ENGINEERING INSTRUCTION

NEW YORK STATE DEPARTMENT OF TRANSPORTATION

SUBJECT: MODIFICATIONS OF BRIDGE RAILING UPGRADING; SHEETS BDD 79-57A, 79-57B, AND 79-57C.

Code: EI-80- 11

SKETCH #1
For BDD 79-57A

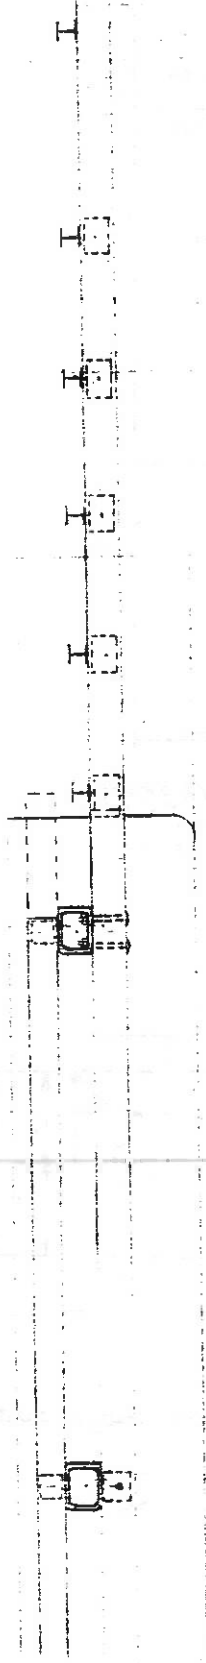
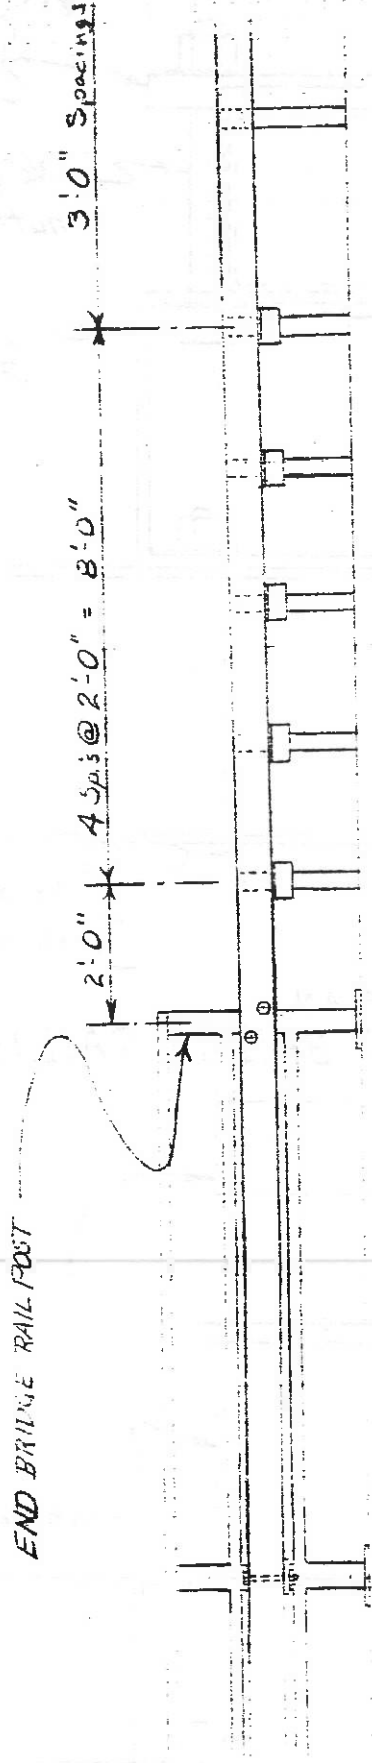
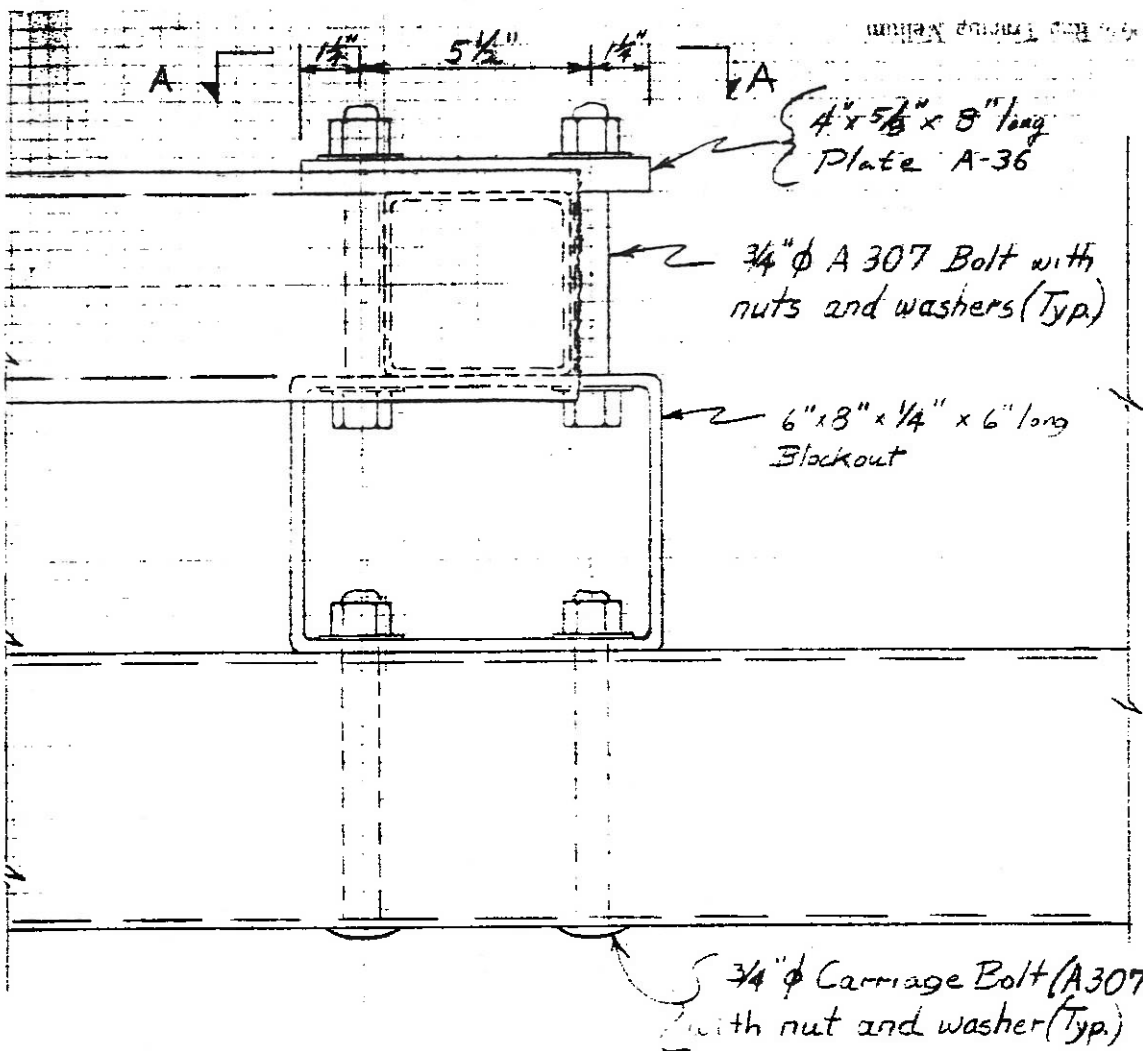
BDD 79-57A - The transition from weak post guiderail to blocked out box beam was not previously detailed on this sheet because it wasn't necessary. Effective immediately, the details on the Numbered 1 and 2 attached sketches, are to be used in conjunction with this sheet. We have removed the seat angle on the end bridge post and added carriage bolts in their place. In addition, the highway seat angle has been added to the first five (5) weak posts adjacent to the end bridge railing post. The remainder of the weak posts shall be spaced as previously detailed on BDD 79-57B and 79-57C.

The modifications will eliminate a potential snag point at the first strong post connection on the structure by removing the seat angle and substituting carriage bolts for the tube to bridge railing post connection. The seat angle, in conjunction with the guiderail flexibility off the structure, due to weak post supports, present a potential snag point.

SKETCH #3

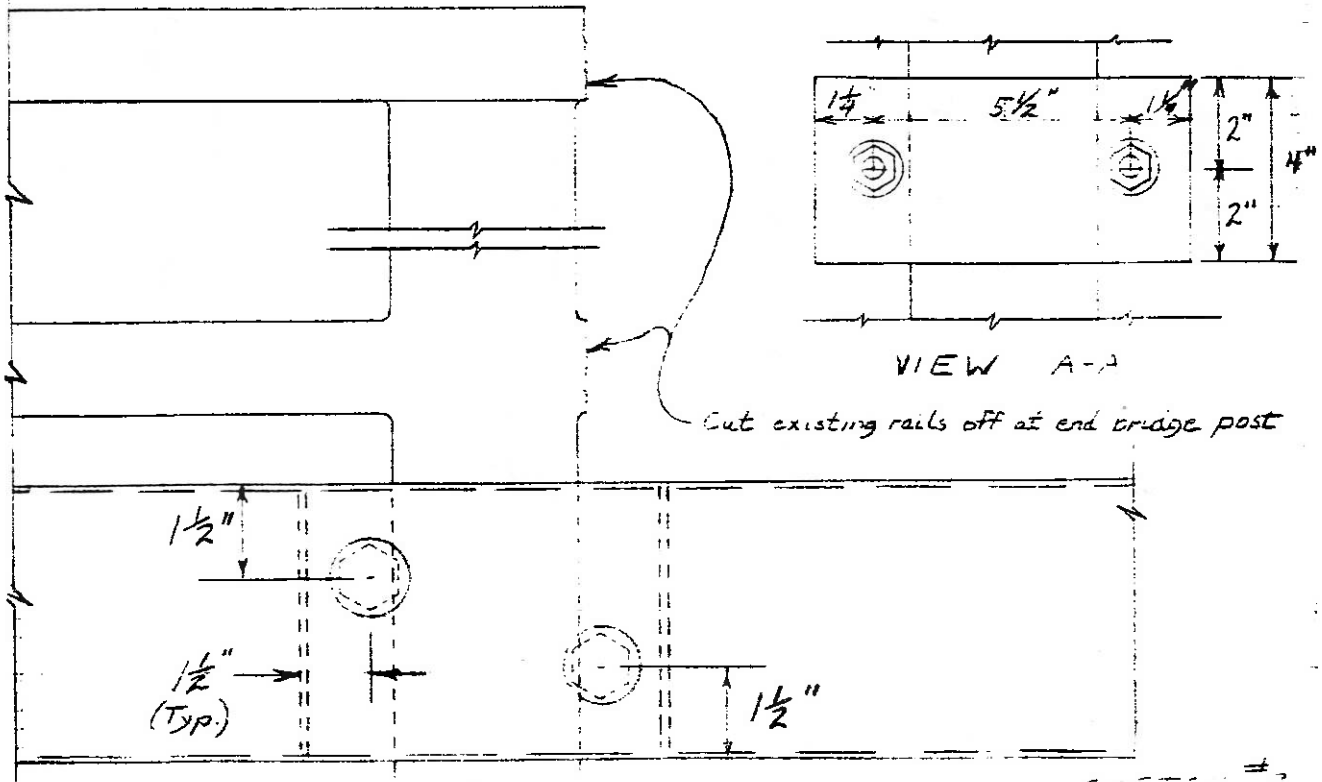
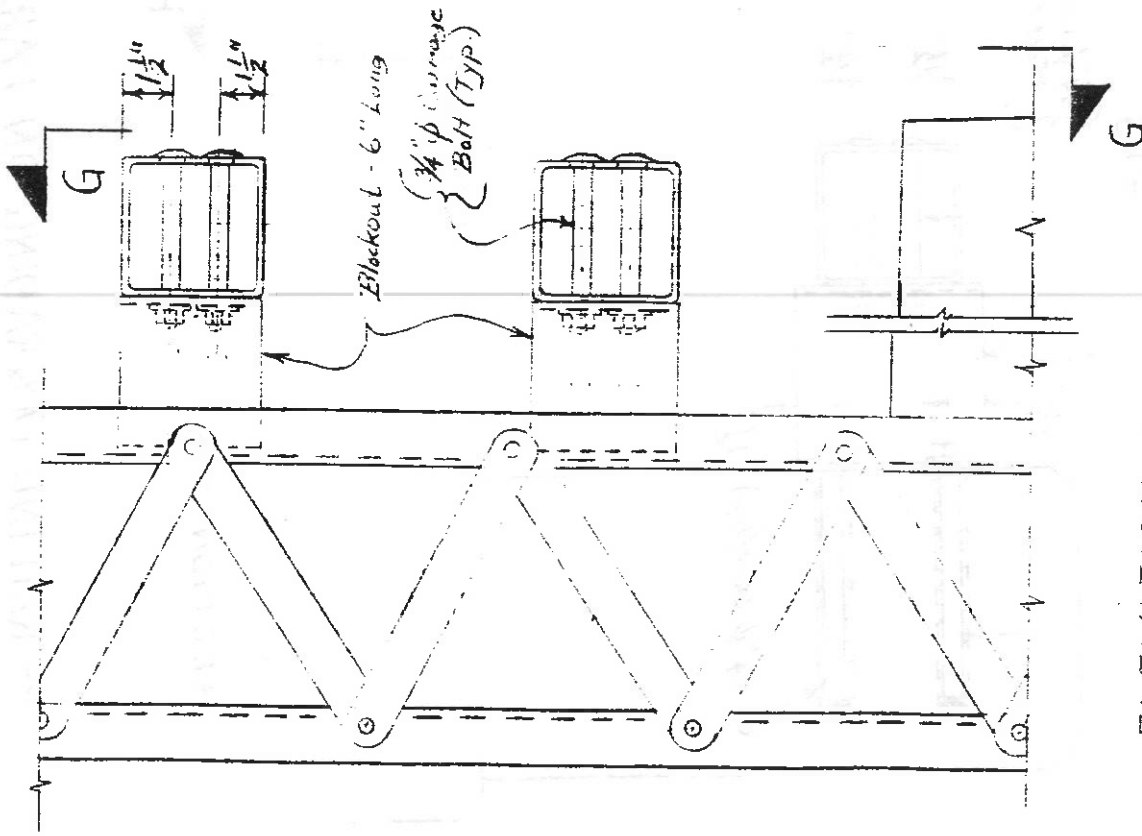
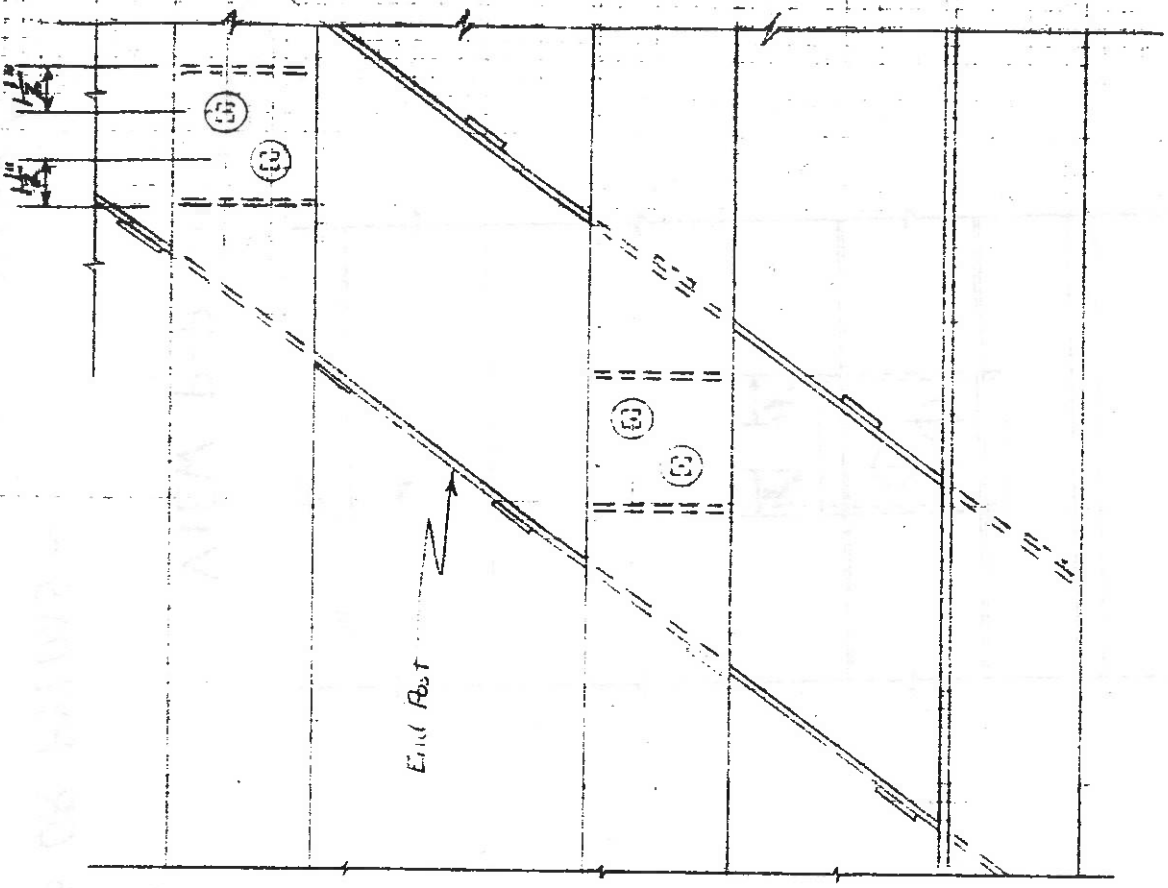
BDD 79-57B - The seat angle on the end post connection of all trusses must be removed and carriage bolts substituted in that connection as shown in Sketch 3.

SKETCH #4
 Date: FEB 79-576

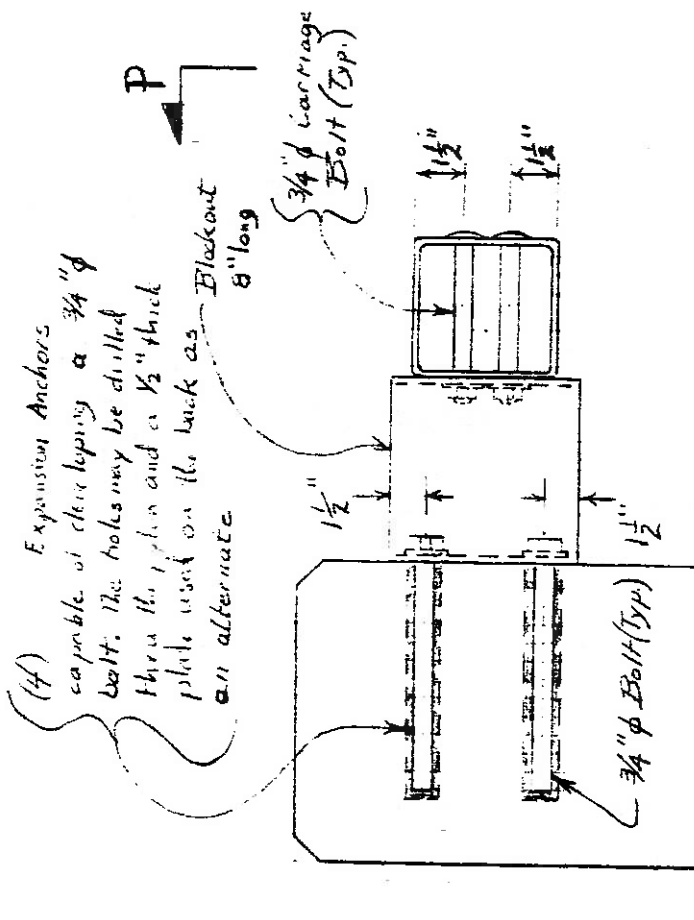
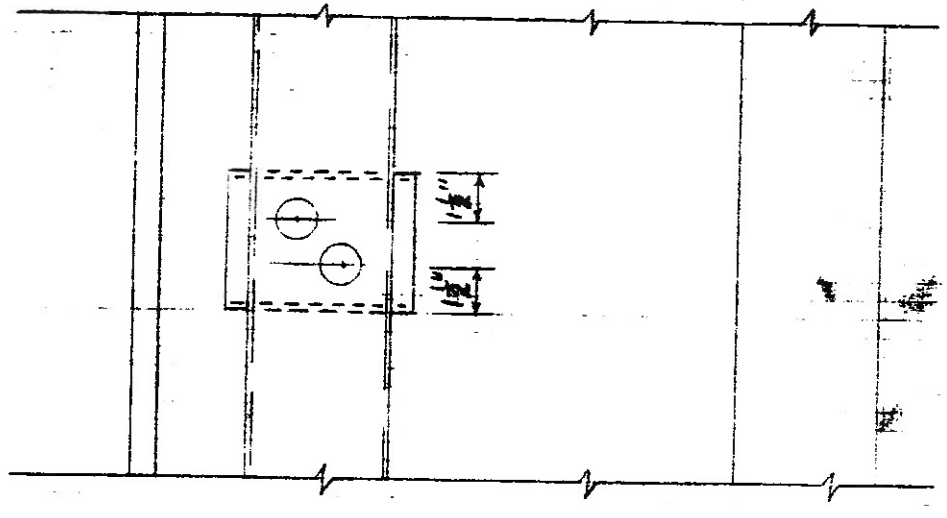
BDD 79-57C - On the connection to all pylons, the seat angle must be removed and carriage bolts substituted in that connection as shown in Sketch 4.
